Service Bulletin

Bulletin No.: 16-NA-203

Subject: Active Shutters Inoperative During Cold Ambient Temperatures, Malfunction Indicator Lamp (MIL) Illuminated - DTC P059F Set Current or in History

Brand:	Model:	Model Year:		VIN:		Engine:	Transmission:
				from	to		
Chevrolet	Volt	2016	2017

4538157

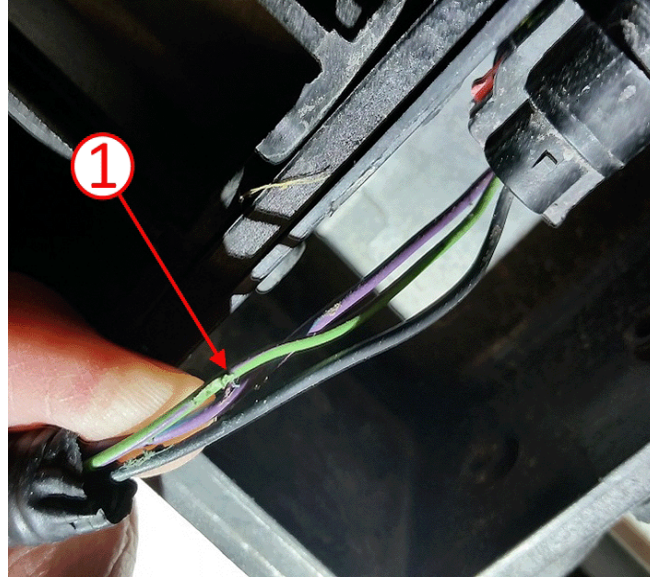
Inspect the active shutter wiring harness for any signs of chafing (1).

- If any chafing was found on the wiring harness, the harness must be repaired as needed.
- If the wiring harness has been found in working order and does not need repairing, using care, perform inspection on the shutters for any signs of snow, ice and/or damage.
